SERVICE BULLETIN

BULLETIN NUMBER: 266

SUBJECT: PN 54760 Fuel Module Drain Plugs

MODEL: 3.5 SBCG-612 and 3.5 SBCG-512 "EFI Low CO"

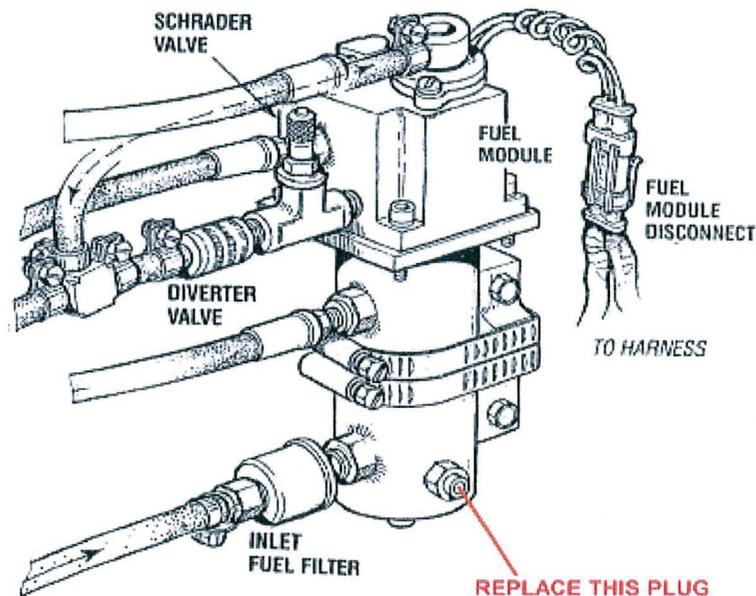
DETAIL: The 1/8 NPT sea water drain plug in the Fuel Module illustrated below is made of steel requiring replacement with solid brass hex head plug Westerbeke PN 19369.

3.5 SBCGs with engine serial number date codes LA thru LI (manufactured January 2012 to September 2012) are affected.

Owners having units that fall within these manufacturing dates are advised to have this drain plug replaced as soon as possible or at the next service interval.

The correct replacement drain plug can be acquired by contacting Westerbeke Corporation or your local Westerbeke Distributor or Dealer.
